# MONITORING YEAR 2 ANNUAL REPORT

## VILE CREEK MITIGATION SITE

Alleghany County, NC  
DEQ Contract No. 5999  
DMS Project No. 96582

RE: **Response to MY2 Draft Report Comments**  
**Vile Creek Mitigation Project**  
DMS Project # 96582  
Contract Number 5999  
New River Basin - #CU# 05050001 - Alleghany County, North Carolina

**Table 5a. Visual Stream Morphology Stability Assessment Table**

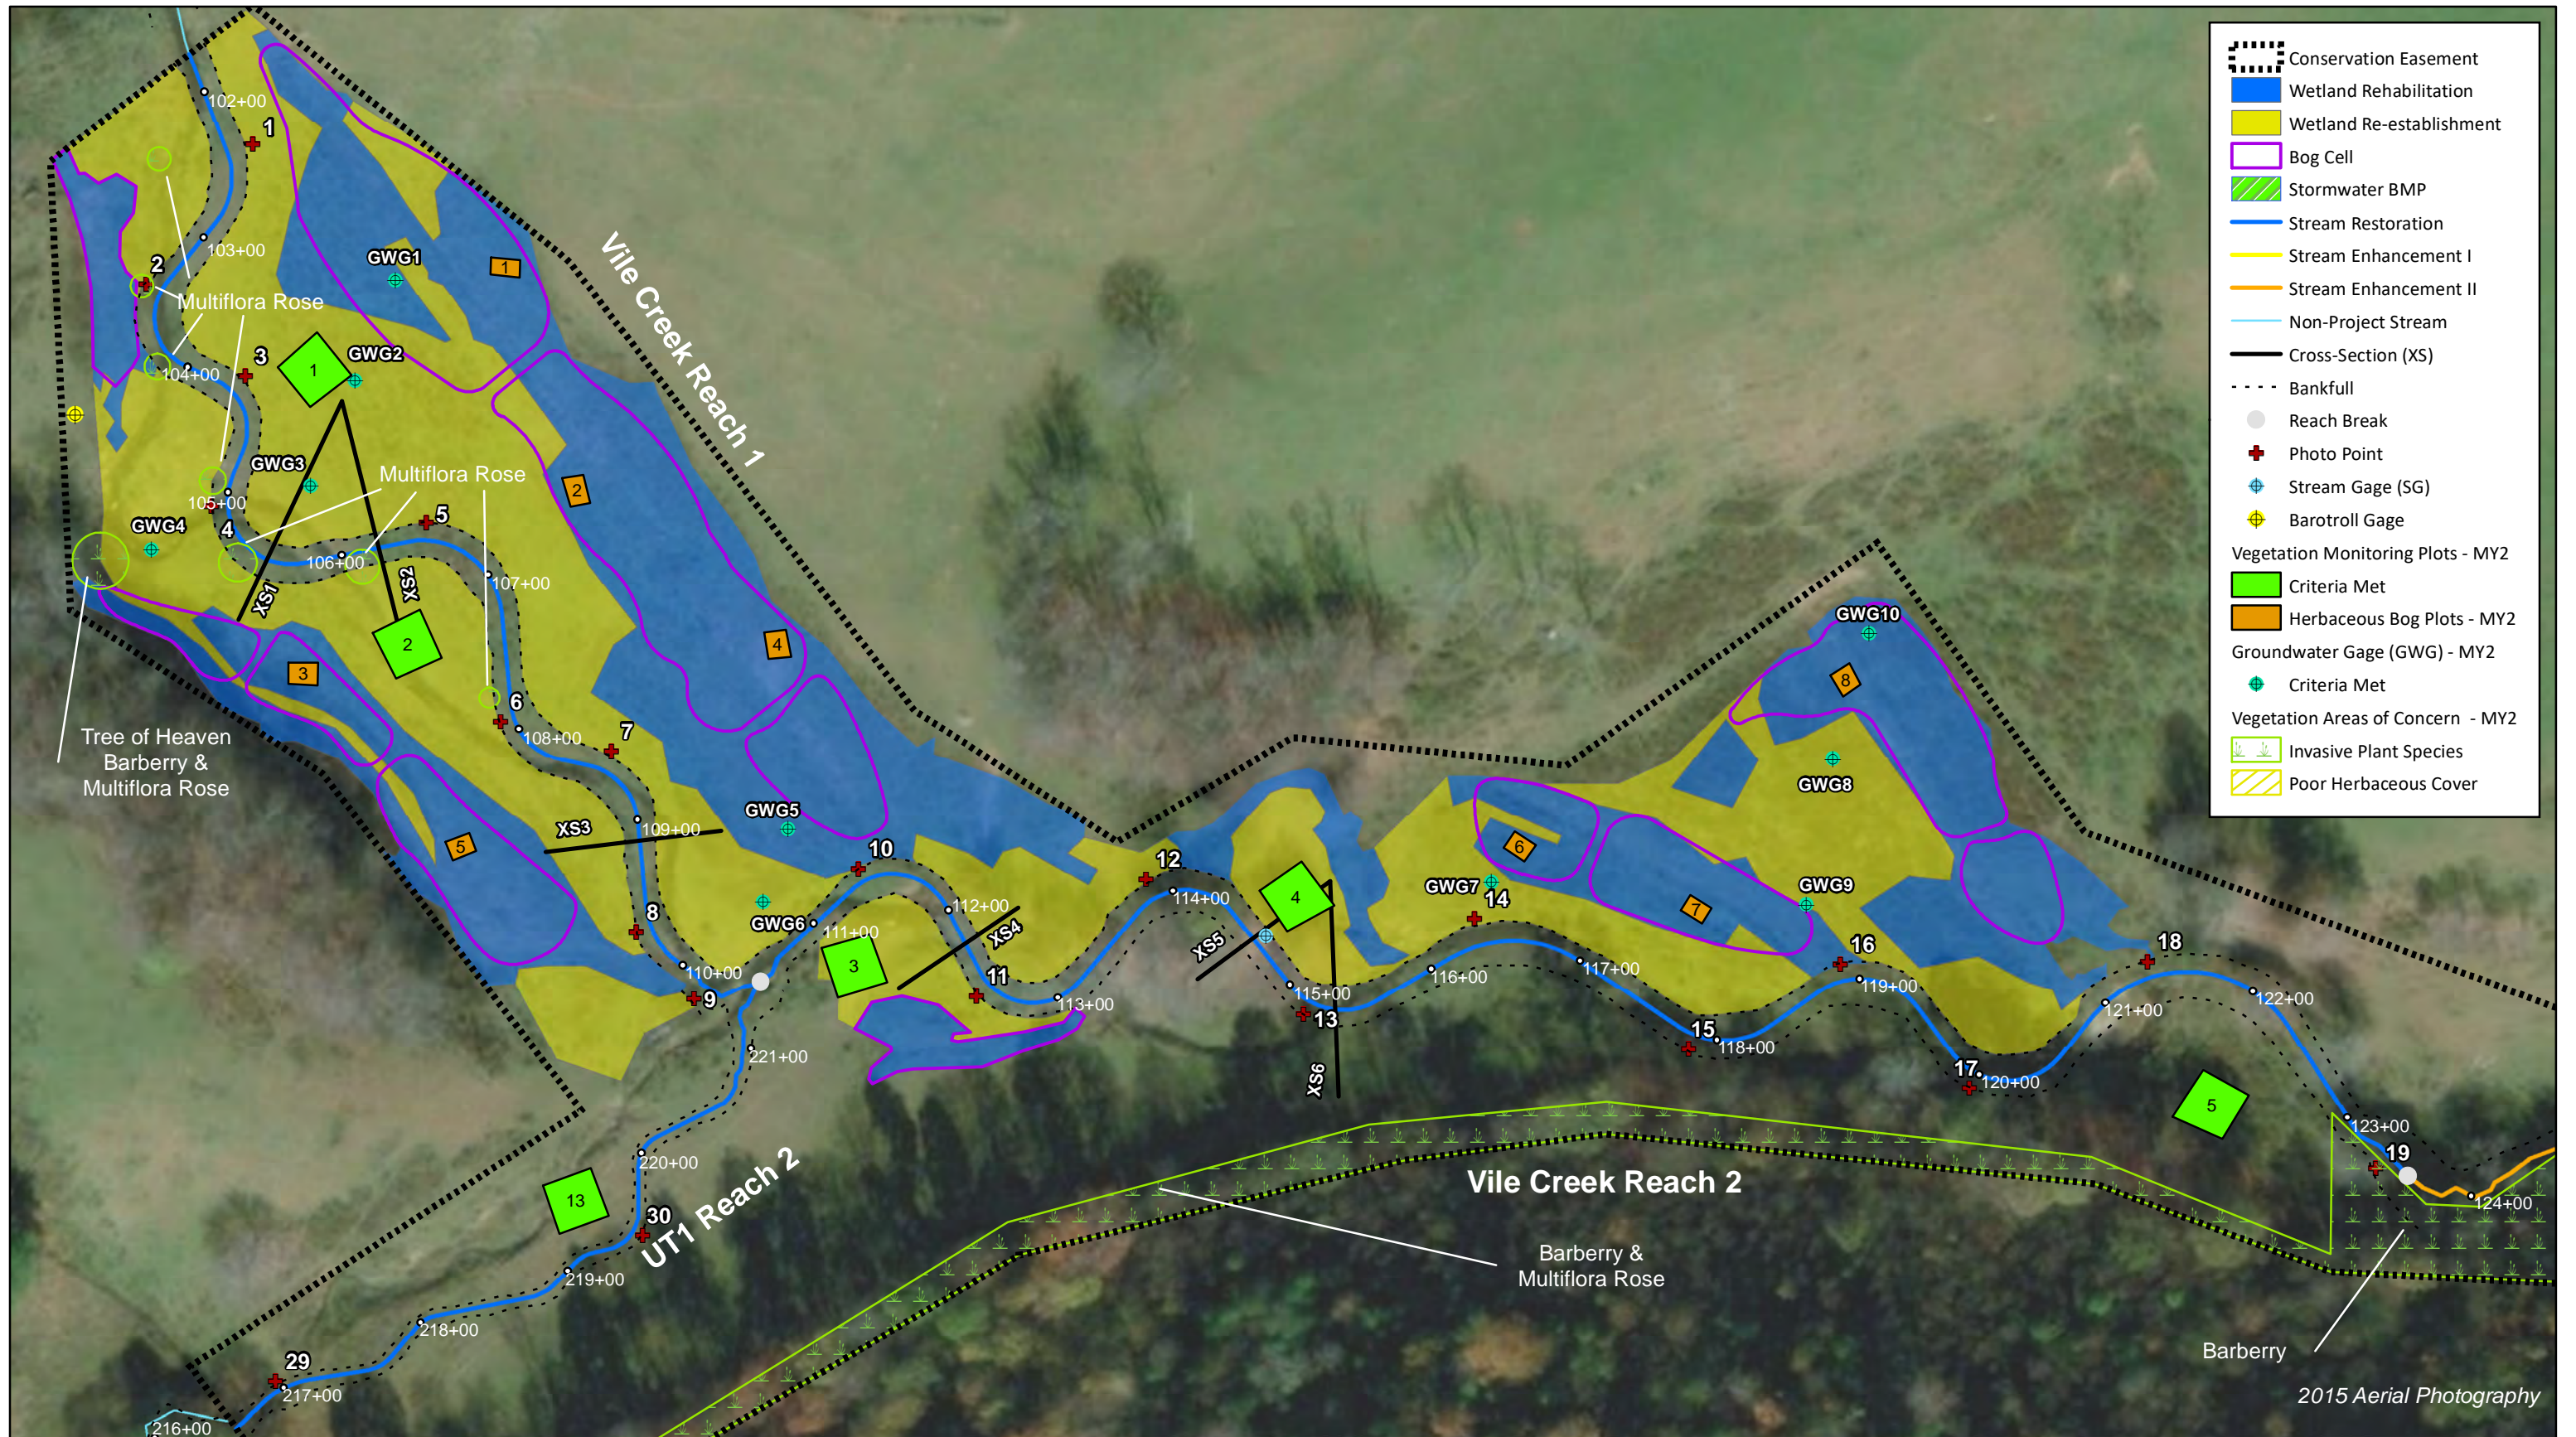
**DMS comment;** It would be helpful to show the station numbers on the CCPVs so the reader can match the narrative with the maps.

**DMS comment;** Visual Assessment tables – Localized areas of scour /erosion are noted in Section 1.2.5; however, the visual assessment tables on some of these reaches indicate 100% performance. In addition, the “Totals” section for ‘Bank’ does not seem to be summed accurately in some instances. Please reexamine the visual assessment tables and provide an up-to-date and accurate depiction of areas of scour/erosion, undercut banks, etc. and totals following the fall 2018 major storm events.

*Wildlands response; Wildlands has updated the CCPV maps to include the longitudinal stationing.*

*Wildlands response; Wildlands has updated the CCPVs to remove the stream areas of concern that do not meet the mapping threshold. The visual assessment tables (5a-5e) were also updated to reflect an accurate depiction of scour/erosion performance. Section 1.2.5 was updated to clarify the areas are under the mapping threshold and correct station numbers.*
